IPC-2221

Generic Standard on Printed Board Design

Amendment 1

Amendment 1
January 2000

Figure 5-1 Example of printed board size standardization, mm [in]

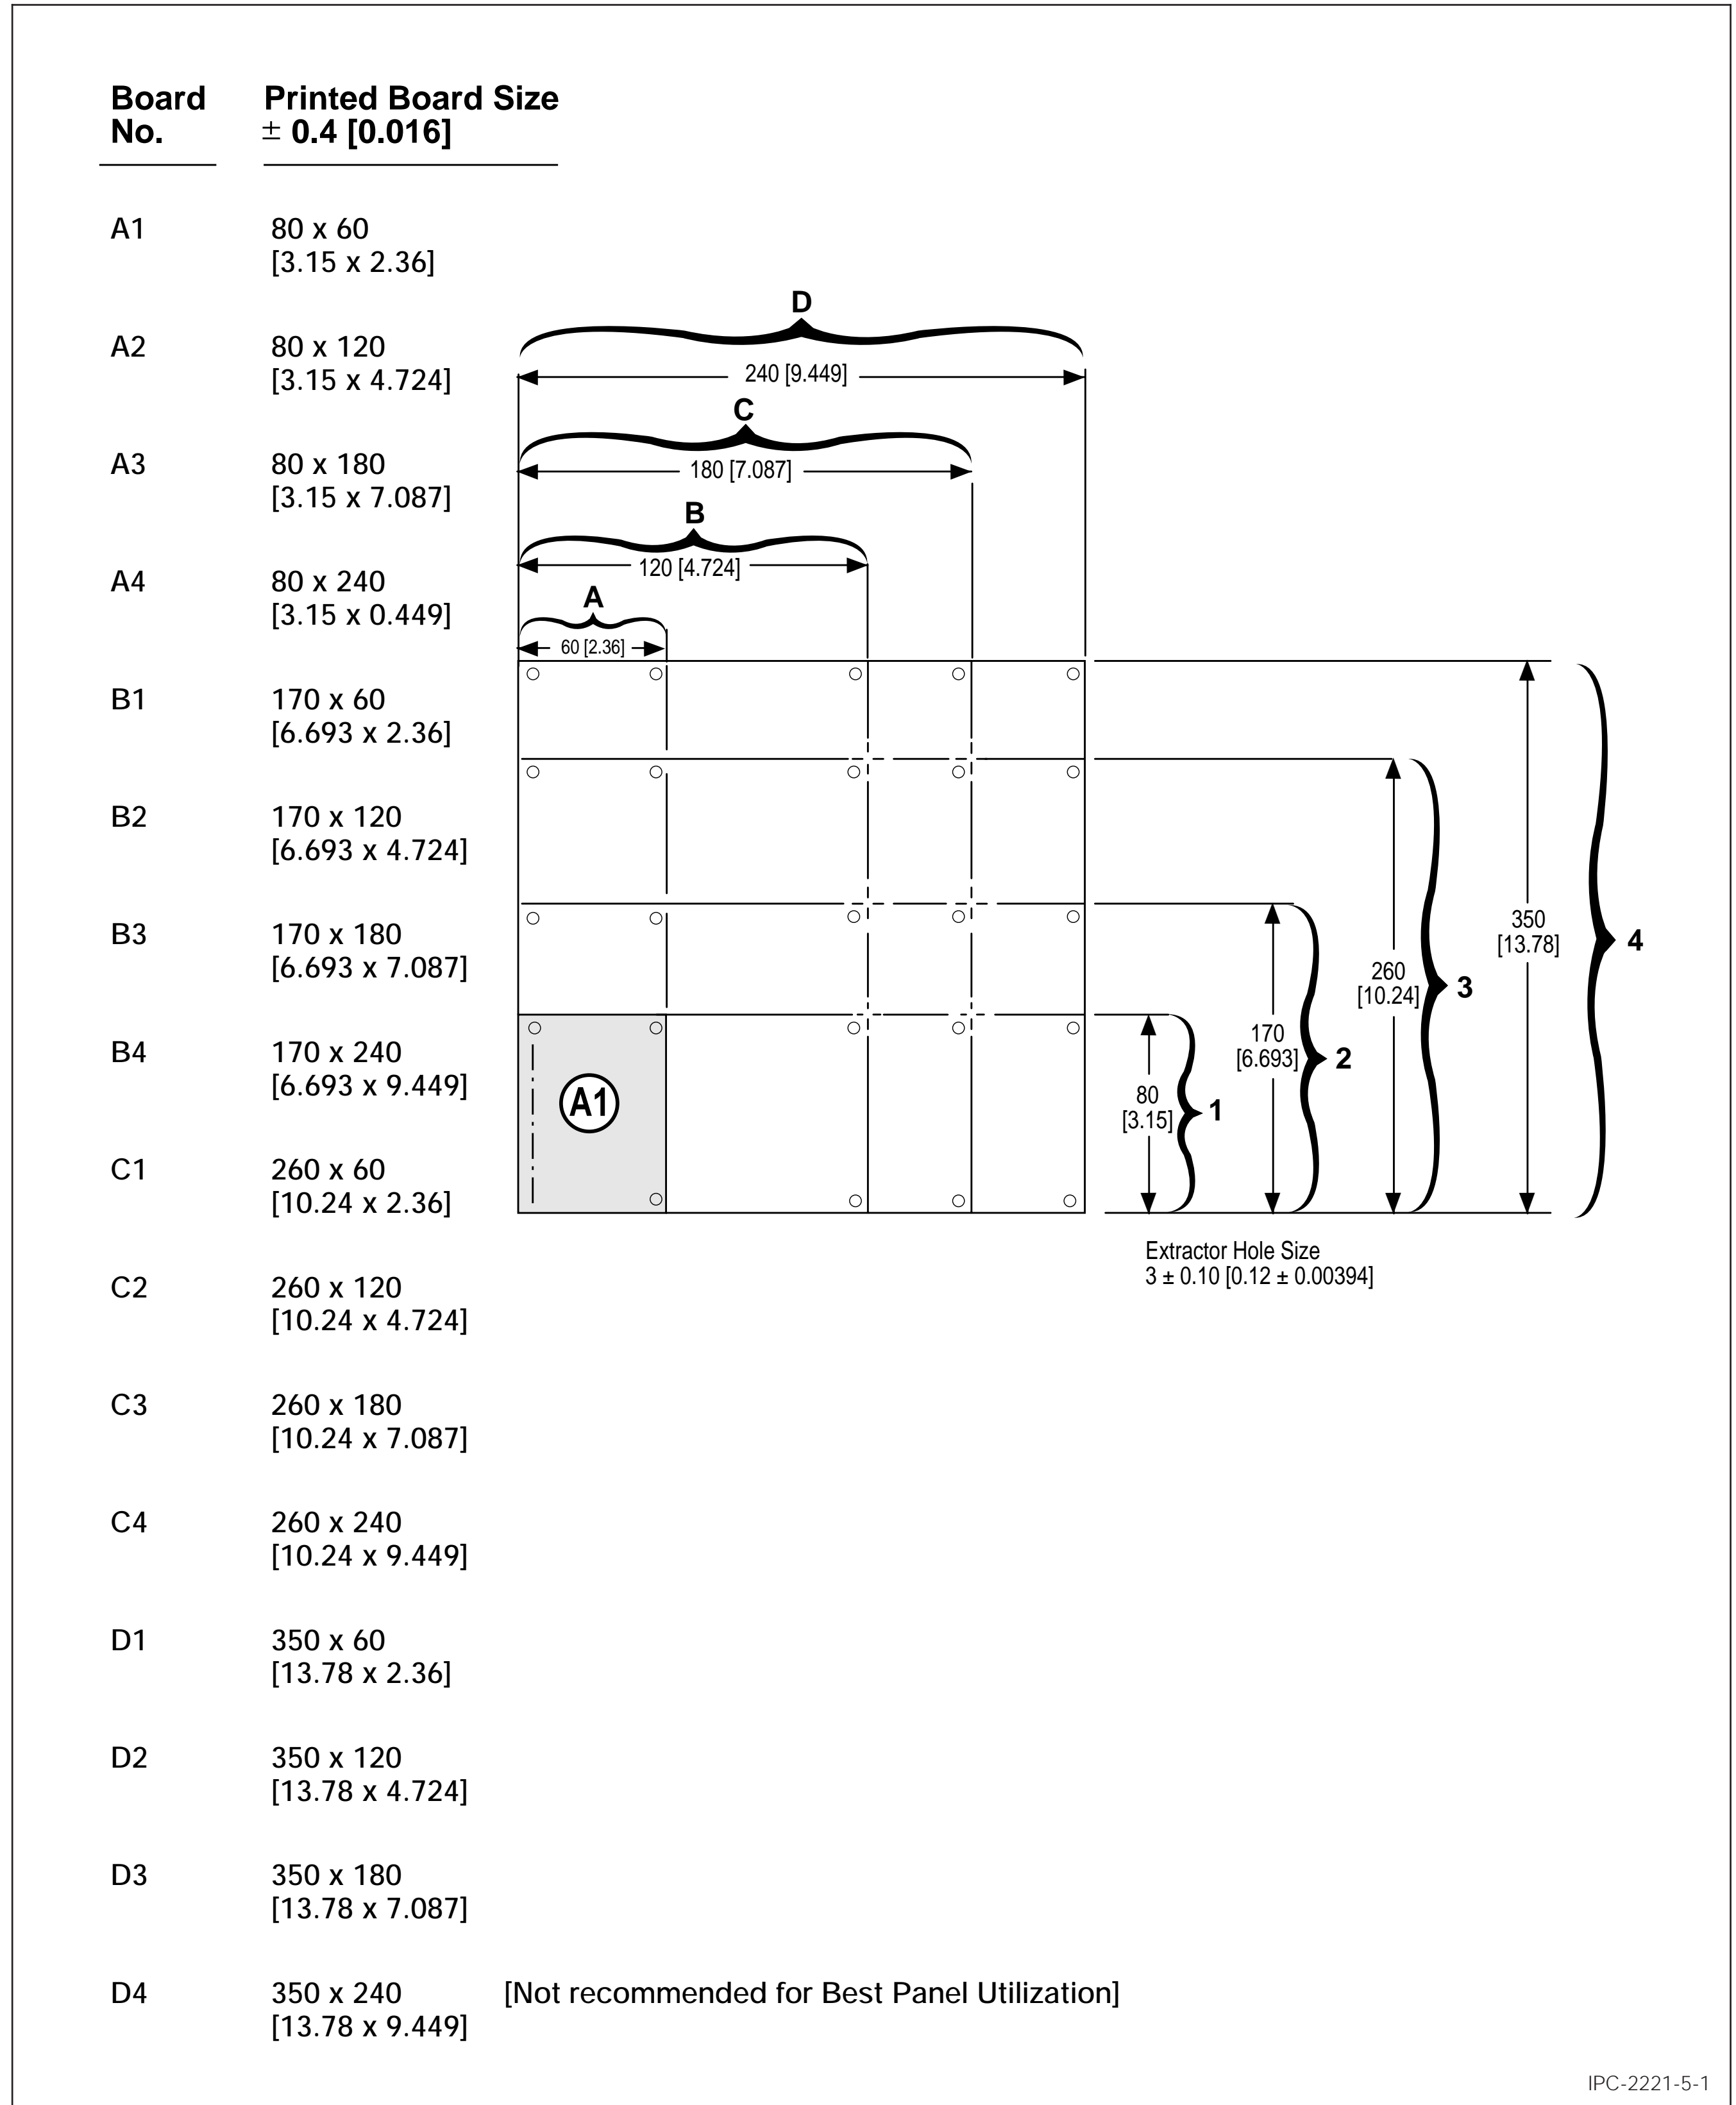
Replace Figure 5-1 as follows:

Board No.	Printed Board Size ± 0.4 [0.016]	
A1	80 x 60 [3.15 x 2.36]	
A2	80 x 120 [3.15 x 4.724]	
A3	80 x 180 [3.15 x 7.087]	
A4	80 x 240 [3.15 x 0.449]	
B1	170 x 60 [6.693 x 2.36]	
B2	170 x 120 [6.693 x 4.724]	
B3	170 x 180 [6.693 x 7.087]	
B4	170 x 240 [6.693 x 9.449]	
C1	260 x 60 [10.24 x 2.36]	
C2	260 x 120 [10.24 x 4.724]	
C3	260 x 180 [10.24 x 7.087]	
C4	260 x 240 [10.24 x 9.449]	
D1	350 x 60 [13.78 x 2.36]	
D2	350 x 120 [13.78 x 4.724]	
D3	350 x 180 [13.78 x 7.087]	
D4	350 x 240 [13.78 x 9.449]	[Not recommended for Best Panel Utilization]

Figure 5-7 Datum Features for Panelization

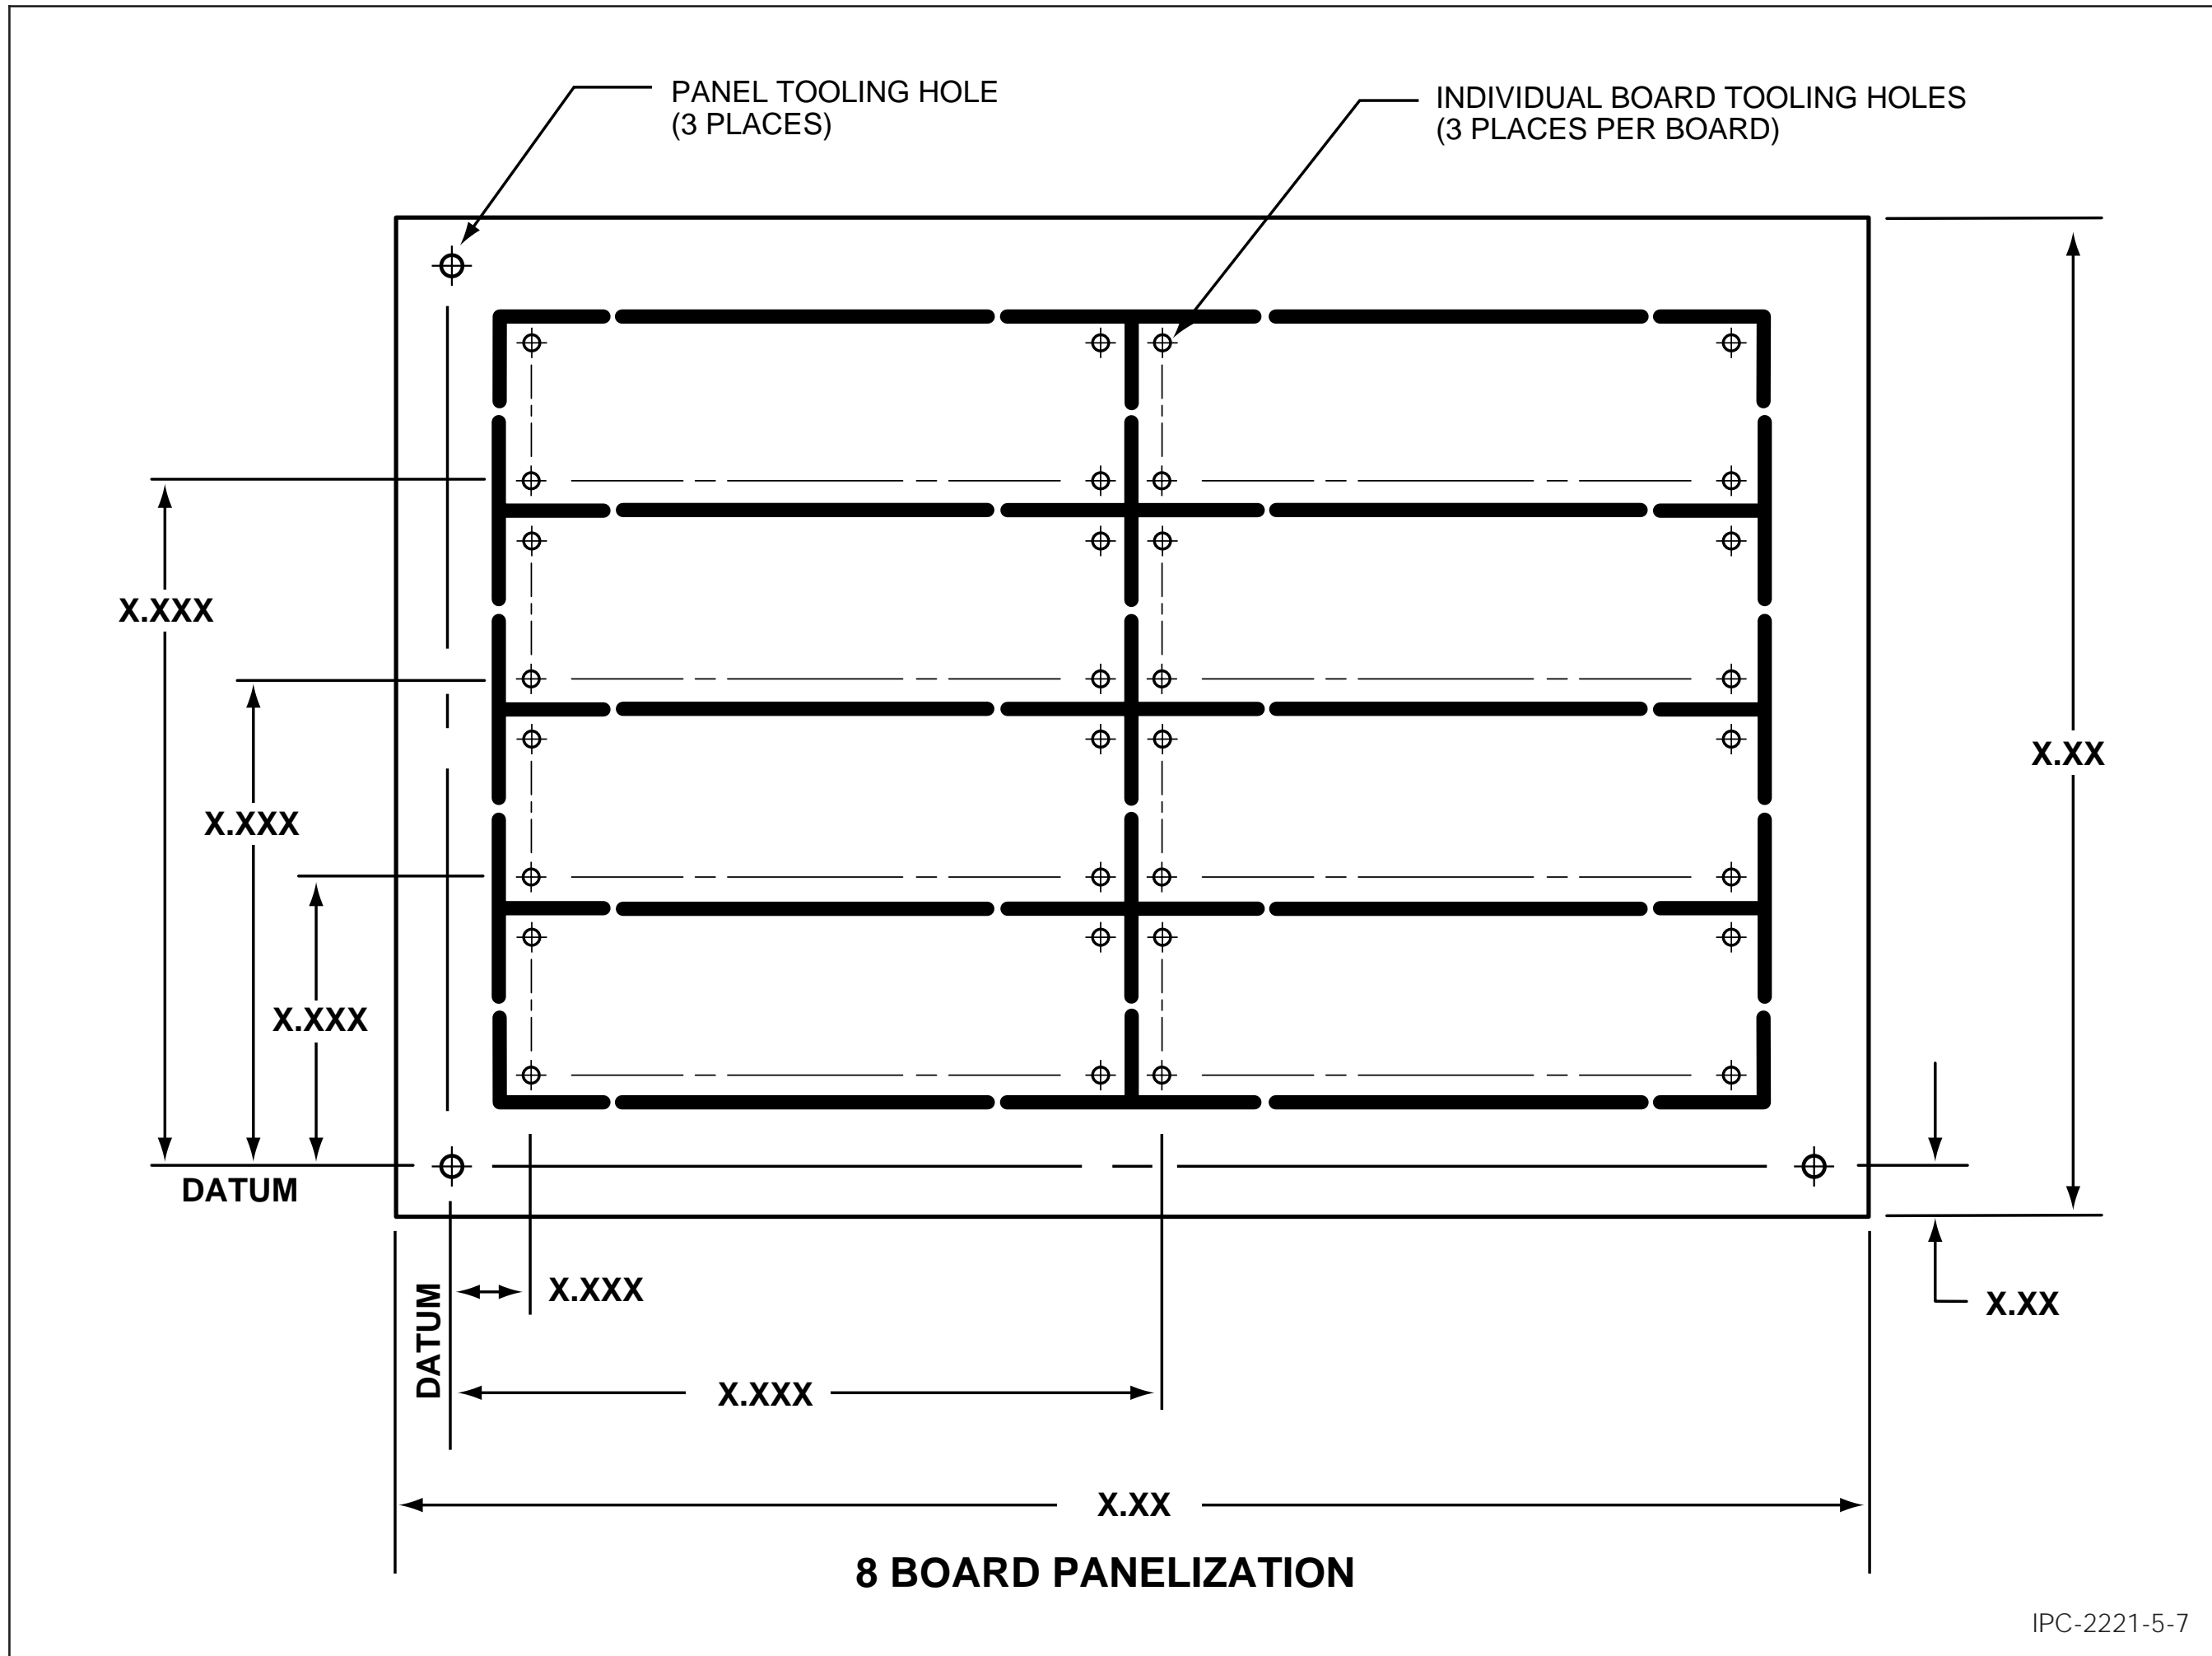
Replace Figure 5-7 as follows:

Figure 6-7 Capacitance vs. conductor width and spacing for striplines, mm [mils]

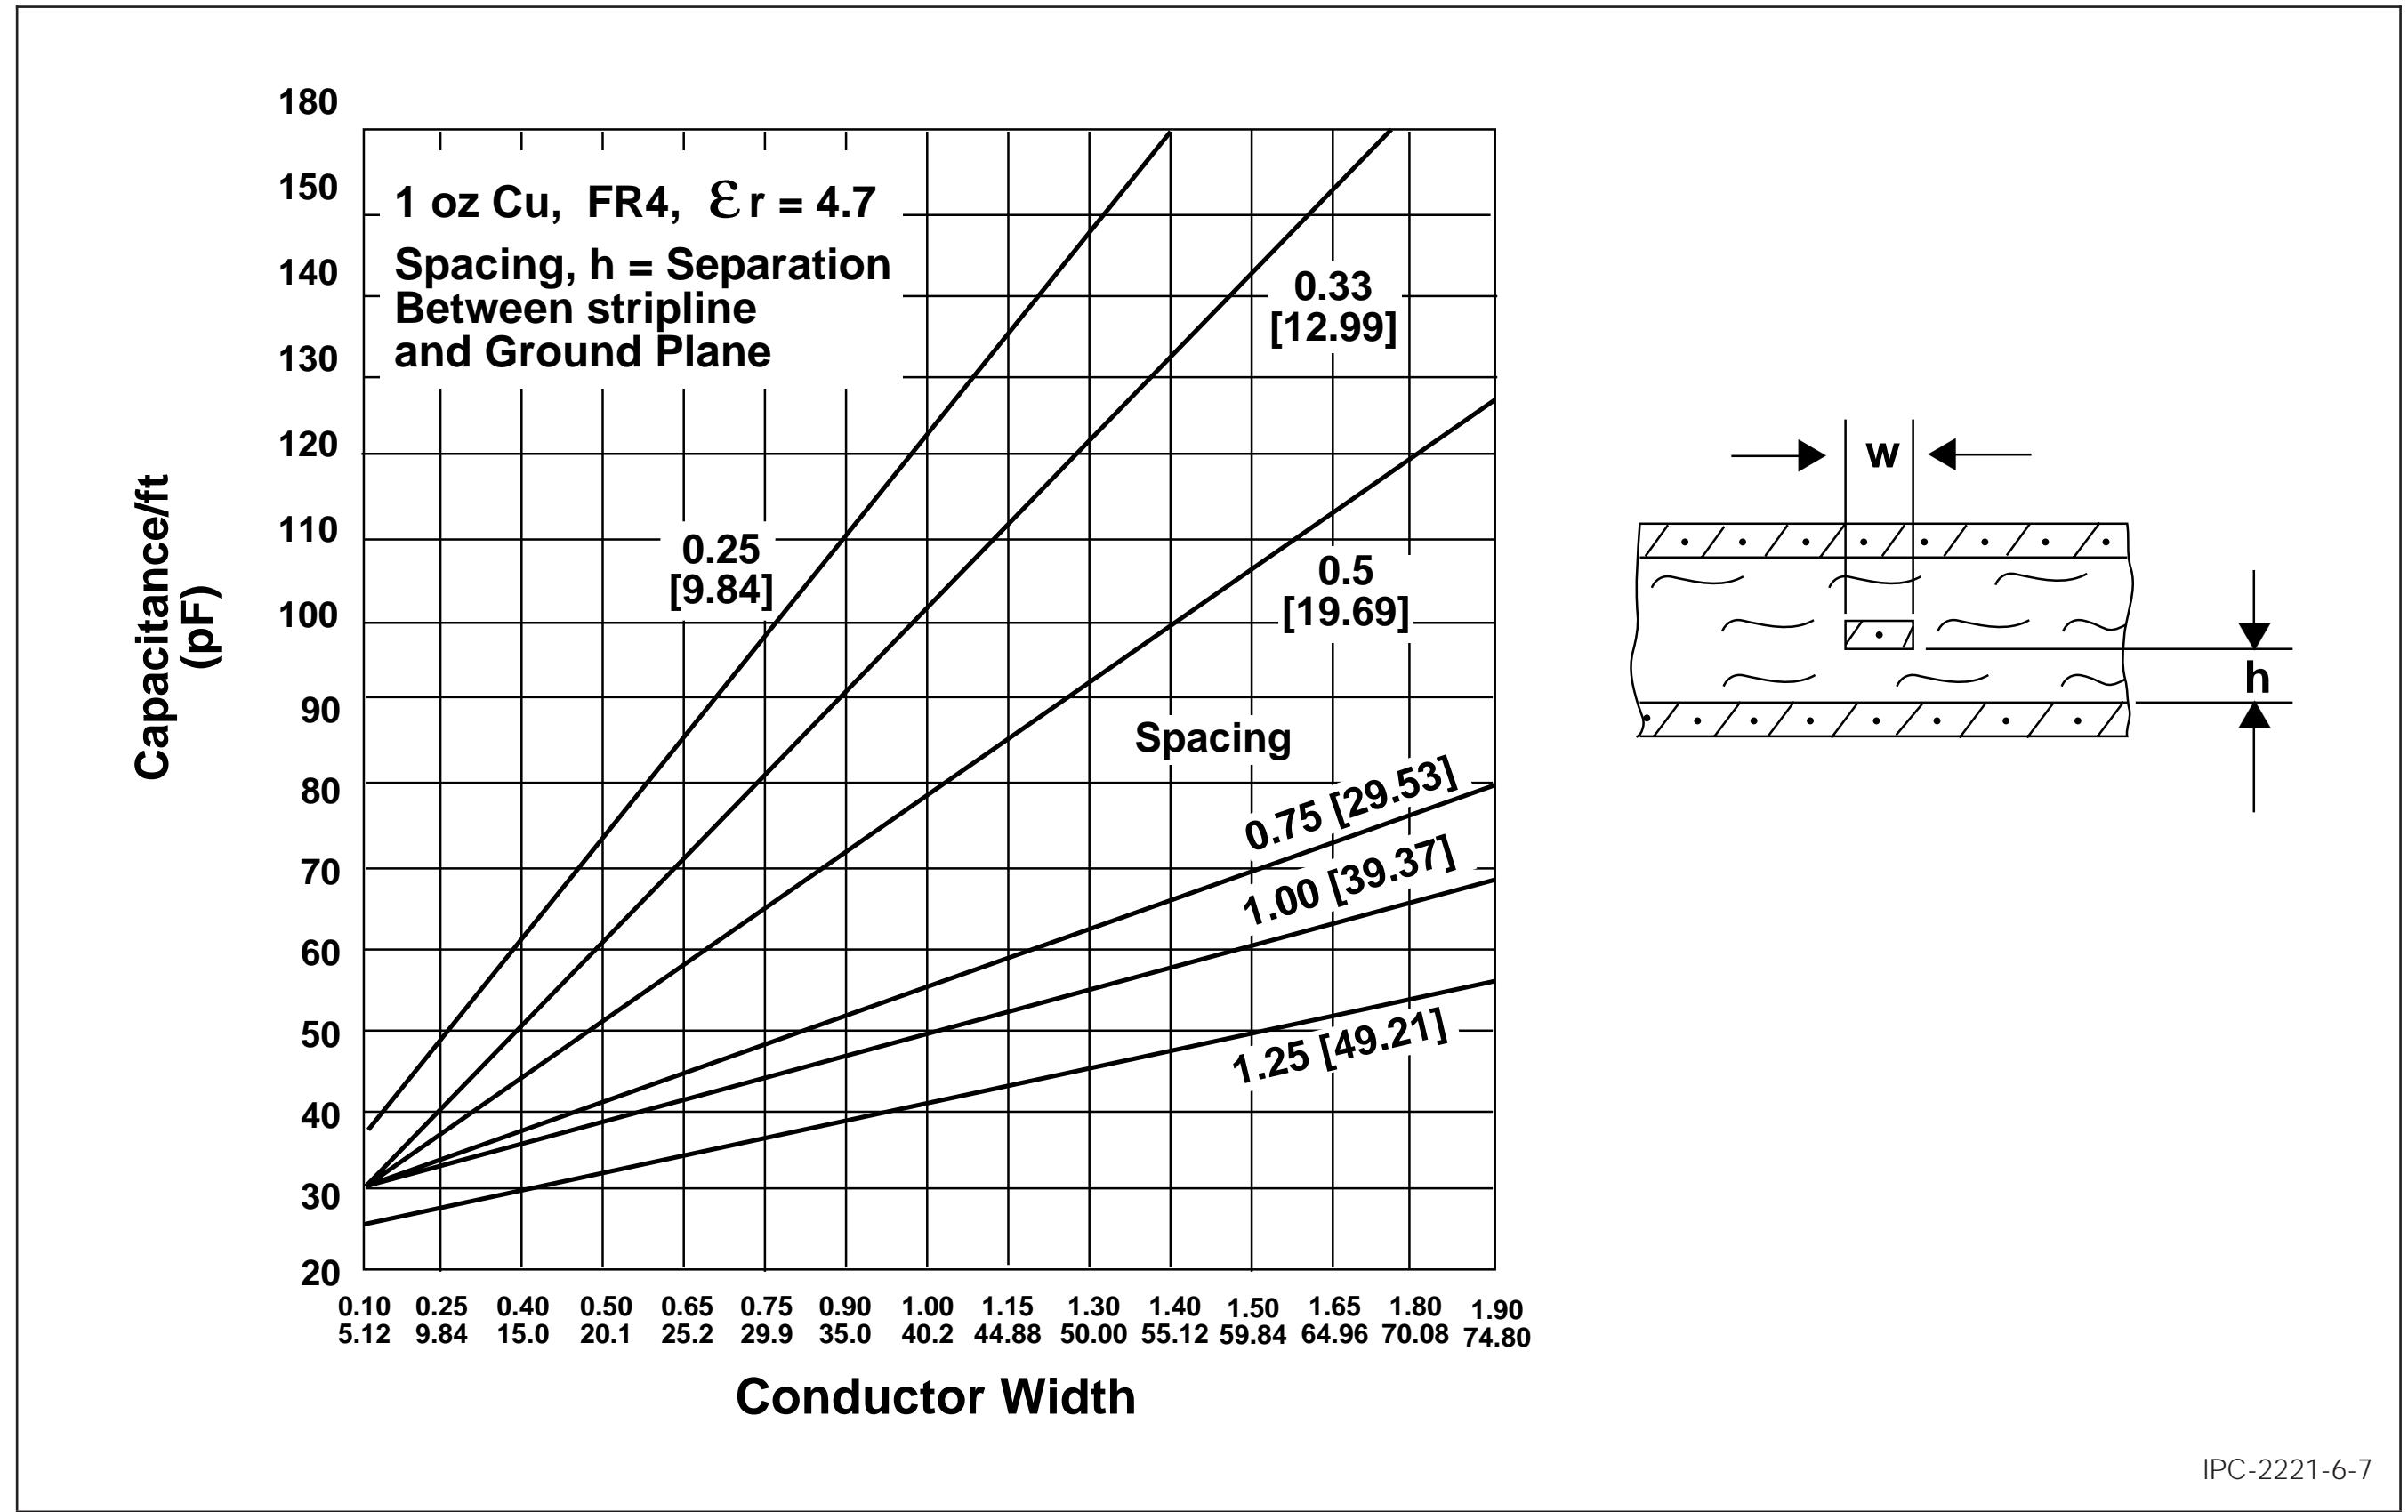
Replace Figure 6-7 as follows:
